PLANNING & REDEVELOPMENT DEPARTMENT STAFF REPORT DESIGN COMMITTEE MEETING AUGUST 21, 2008

<u>ITEM III-A</u> DESIGN REVIEW PERMIT – BP/ARCO REMODEL - 1139 DOUGLAS BOULEVARD – FILE # 2008PL-063 (DRP-000264)

The applicant requests approval of a Design Review Permit to allow the demolition of the existing ARCO AM/PM convenience store and fuel canopy to be replaced by construction of a new convenience store, car wash, fuel canopy, and associated site improvements including parking and landscaping.

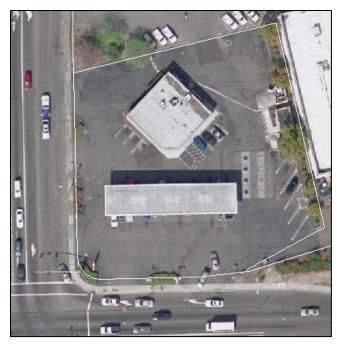
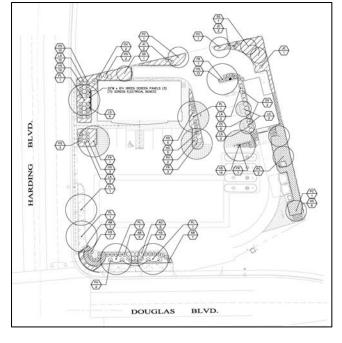
The existing landscape setback is intermittent and varies from five (5) feet to twelve (12) feet in width along Douglas and Harding Boulevards. A landscape planter spans the length of the eastern property line. The width of that planter varies from nine (9) feet wide at the north end, approximately twenty-two (22) feet wide in the middle, and eight (8) feet wide at the south end.

The landscape setback proposed along the Harding Boulevard frontage varies from seven (7) feet to twenty (20) feet. The setback will be seven (7) feet along the southern portion of the Harding frontage to accommodate the City's standard twenty-four (24) foot wide drive aisle. The landscape setback to the north of the driveway meets the twenty-foot setback recommended in the Community Design Guidelines.

The applicant proposes a twenty-foot wide planter along the southwest portion of the Douglas Boulevard frontage. Due to the location of the driveway, existing CalTrans right-of-way, and an existing access easement to the adjacent (east) property, it is not practical to provide additional landscaping along the southeast Douglas Boulevard frontage. The Community Design Guidelines allow flexibility to deviate from the 20-foot requirement in circumstances where it is not practical or feasible to provide 20 feet of landscaping.

Staff supports the proposed landscape setback for two reasons:

- 1. The proposed landscape setback exceeds both the existing landscape setback at the project site and the existing landscape setbacks along both Harding Boulevard and Douglas Boulevard in the surrounding area.
 - The average landscape setback for commercial development along Douglas and Harding Boulevards is approximately 15 feet wide, as measured at 10-foot intervals for 400 feet along both Douglas and Harding and then averaged. The average landscape setback proposed along Douglas and Harding Boulevards with this project is 15'5" wide.
- 2. Staff believes that the quality of the landscaping proposed meets the intent of the "priority shalls" described in the Community Design Guidelines.
